Economic Commission for Europe

Working Party on the Transport of Perishable Foodstuffs

Proposals of amendments to the ATP:

Pending issues "Multi temperature multi compartment equipment" (MTMC)

Example of the plate

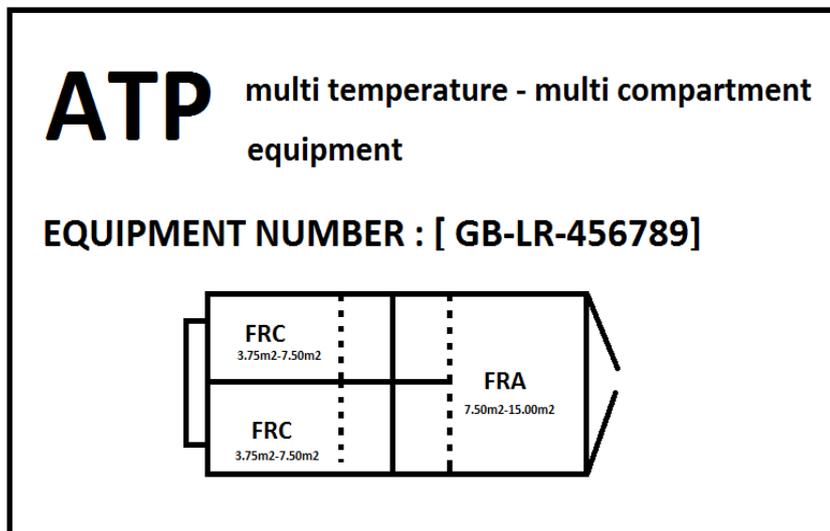
3. *For equipment certified as Multi-temperature-Multi –compartment, when a ATP certification plate is fitted, an additional plate shall be affixed to the equipment in a*

permanent way and in a clearly visible place adjacent to the ATP certification plate. The additional plate shall have the same properties for material and dimensions as the certification plate of paragraph 1. The following particulars shall be indicated on this plate:

(h) Overhead plan view of the load area of the equipment as required in Annex 1, Appendix 2 model No. 11, including position of the compartments, minimum and maximum floor surface and distinguishing marks applicable for each compartment. Fixed walls shall be identified by a closed line, movable by a dotted line in the most extreme positions and a removable wall shall be identified by a waved line. The position of the thermal appliance and doors shall also be given.

Plan (overhead view) of the equipment

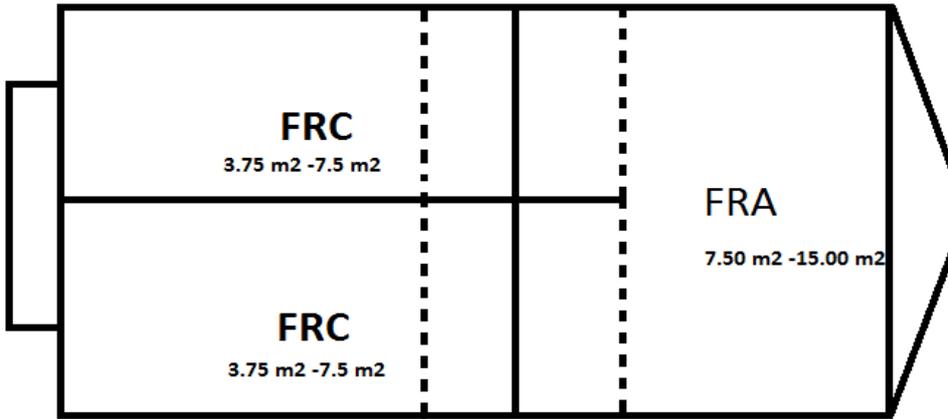
Introduce a new Model No. xy at the end of Annex 1 Appendix2 to read:

Information on the internal configuration of Multi Compartment - Multi Temperature equipment, heat demand of compartments and refrigerating capacity of individual evaporators.

*Number the compartments starting at the left front compartment of the equipment and proceed numbering clockwise.

*Mark the classification mark of each compartment in the appropriate compartment.
